473-477 CONGRESS STREET #3(1952-1958)

TYPICAL
FLOOR
PLAN
OF
OFFICES
CHAPMAN
BUILDING

Herbert W. Rhode
Architect
Portland, Maine

SURVEY OF MEANS OF ACCESS TO FIRE ESCAPE IN UPPER STORIES OF CASCO BANK
(CHAFFIN) BLDG. AT 477 CONGRESS STREET

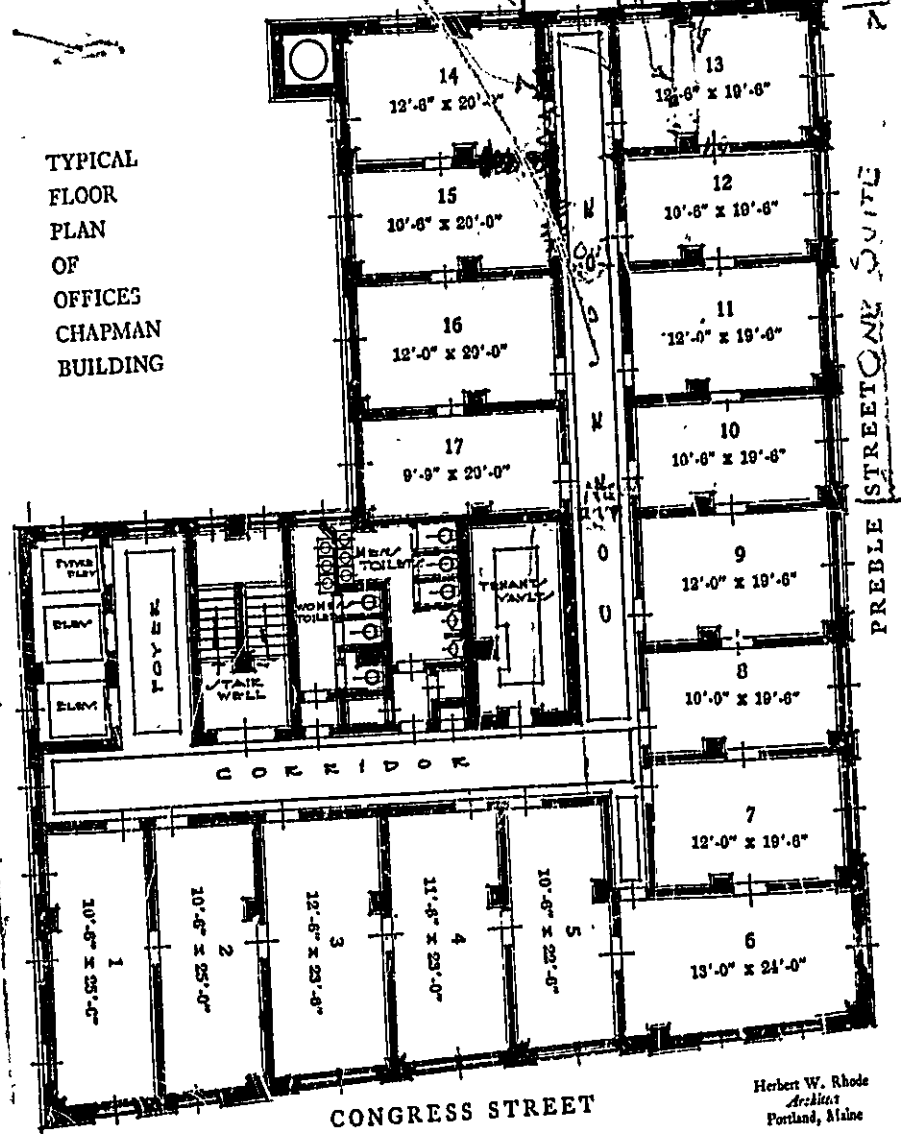
Building permit for alterations on the sixth floor at 477 Congress St. is issued herewith subject to the following conditions and with reference to our letter of Jan. 12th to Mr. Palmer. If these conditions are not understood, or if you are unable or unwilling to comply with them, it is important that you do not start the work and that you contact this office immediately with further information.

1. The owner proposes to care for the means of egress problem by using one of their stock doors in the corridor which has a glass panel at the top of the door, which will be adjusted by cutting off the upper part of the glass and providing the horizontal "H" bar about six inches above the bottom of the panel opening, the glass above the bar to be 7/16 inch glass but the glass below the bar to be either 1/8 inch thick "hazared" glass or standard double thick glass. This lower part of the panel will be high enough and close enough to the door knob on the inside so that a person on the outside having broken the glass can easily reach through and turn the knob.

The door will be equipped with a vestibule lockset which can always be opened by turning the knob on the inside and there will be no other locks or fastenings of any description. On the thin glass panel will be permanently lettered a warning sign to the effect that in case of emergency the glass should be broken and the inside knob turned to open the door and reach the fire escape - this warning to be put on in such a way that persons on the outside will unerringly know that the fire escape is on the other side of the door and can be reached by following directions. In addition there is to be fastened on a chain of sufficient length near the door a hammer or similar instrument of sufficient weight that any person can easily break the glass with it. Some type of instrument is suggested which would be of sufficient weight to break the glass but of such a character that no one would be tempted to steal it for the ordinary purposes of a hammer.

2. The diagram filed with the application is not very explicit but the permit is issued on the basis that all new partitions are to be of masonry or other non-burnable material.

3. While this feature was not talked over with Mr. Grandin or Mr. Palmer, it seems necessary to require that there be a clear fire escape sign over the window leading to the fire escape from the corridor and that a light be provided burning at all times during the dark hours to illuminate the fire escape sign and at the same time give some illumination so that any obstructions in the former corridor could be avoided. Of course the fastenings of the window leading to the fire escape should be easily operated from the inside at all times and the method of opening the window should be obvious.

The door will be one of our standard corridor doors with the top panel glass. It has been suggested to us by a local glass concern that a 5" or 6" panel of 1/8" hammered glass or a double thick glass be installed in the lower section of the opening. This panel of glass would be separated from the upper panel by a H. Bar which would also support the upper panel. The upper panel would be 7/16" hammered glass. We plan to letter the lower panel with instructions of what to do in case of emergency. The door will be equipped with a vestibule lock set.
